Comment Summary – ZBA – 4631 Sideroad 20 N.– 2nd submission

Re: OPA & ZBA 2nd Submission
4631 Sideroad 20 North (Estill Innovation Hub)
Puslinch, ON

**Re: Estill Innovation Community, Township of Puslinch
Environmental Impact Study, 2nd Submission
Peer Review – Ecology**

**Re: 4631 Sideroad 20N
Proposed Industrial/Commercial Development
2nd Submission**

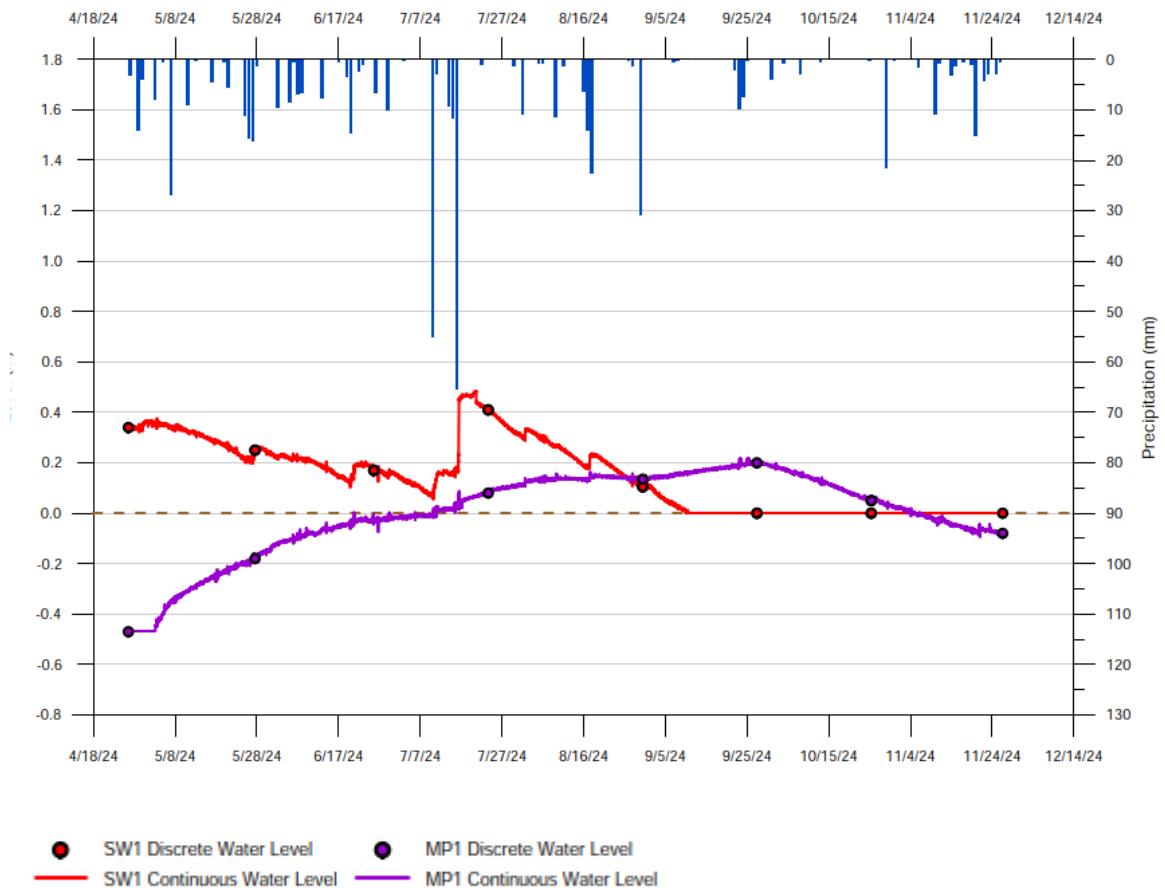
- 1) The water supply report must be updated to include this recommendation. *Any water wells drilled at the site will be fully cased to the lower aquifer if an adequate water supply cannot be obtained from the overburden or Guelph Formation aquifer. There will not be any wellbores open to both the Guelph Formation and the Goat Island/Gasport aquifer.*
